**Re: Response to WDNR's Correspondence dated September 9, 2020
Superior Health Linens / BRRTS #02-41-532649
5005 S. Packard Avenue
Cudahy, WI**

On behalf of D&C Partners, LLC (D&C Partners), St. John – Mittelhauser & Associates, Inc., a Terracon Company (SMA), has prepared the responses in this letter to address comments by the Wisconsin Department of Natural Resources (WDNR) in their letter dated September 9, 2020. Once we have satisfactorily addressed these WDNR comments, we anticipate preparing a Site Investigation / Remedial Action Options and Design Report Addendum (SI/RAODR Addendum) for the Superior Health Linens (Superior) site for submission to the WDNR.

ESTIMATED EXTENT OF GROUNDWATER IMPACTS IN 30-FOOT SAND

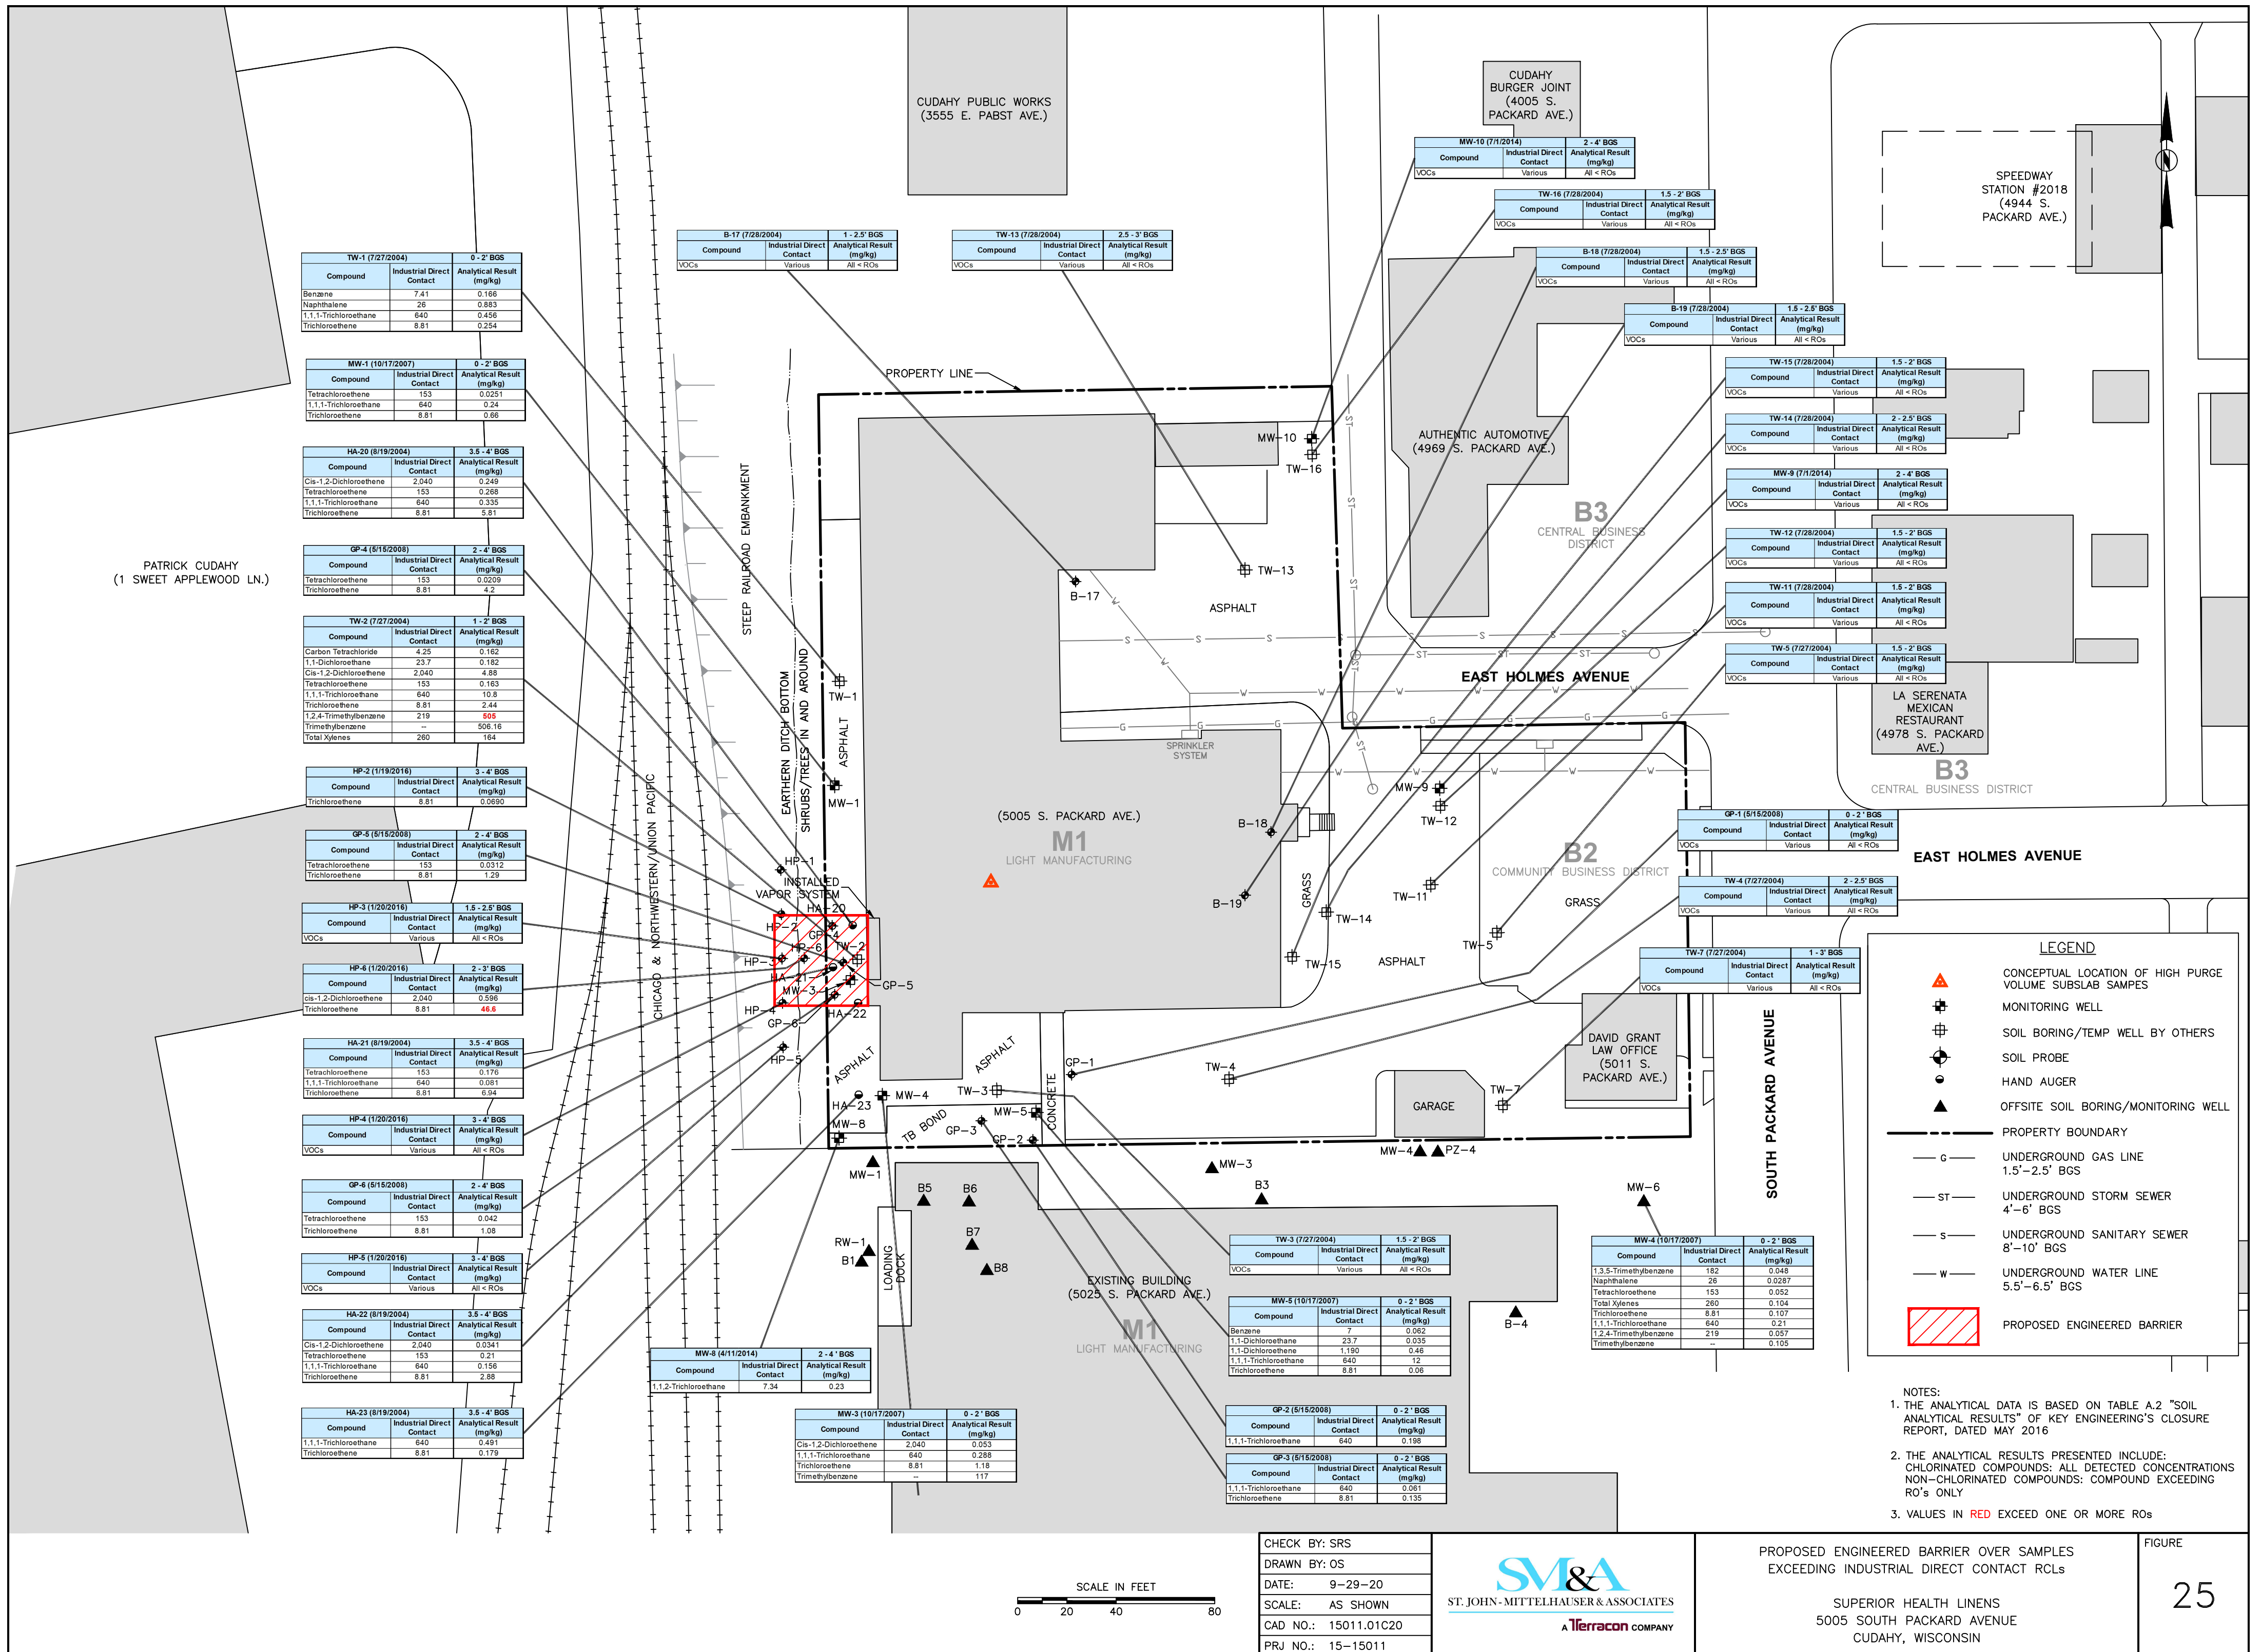
The plume limits depicted on Figure 23 may overestimate of the extent of contamination. The estimated plume limits currently displayed are based on the assumption that groundwater flow direction and stratigraphy do not vary off-site, which may or may not be the case. The DNR recommends reevaluating now the plume limit is displayed on the figure using the analytical data and field measurements that are available. Displaying the groundwater plume to terminate without impacting an offsite property would be a reasonable interpretation. Analytical data confirmed that contaminant concentrations drop significantly away from source area (as indicated by samples collected from PZ-1 and MW-13) and that concentrations with the plume have general declined over time. The model data supports this interpretation by suggesting that any off-site impacts would be relatively limited in extent.

The area impacted by 1,4-dioxin in the deeper sand should be modified as well. Depicting the area impacted by 1,4-dioxin as a continuous plume would be a more accurate interpretation of the sampling data. It appears that MW-14 was also impacted by this compound and should be included within the plume limits.

SMA concurs with the WDNR's assessment of the groundwater plume within the lower sand unit. An updated Figure 23, depicting the groundwater plume in the lower sand unit, is provided in Attachment A to this letter.
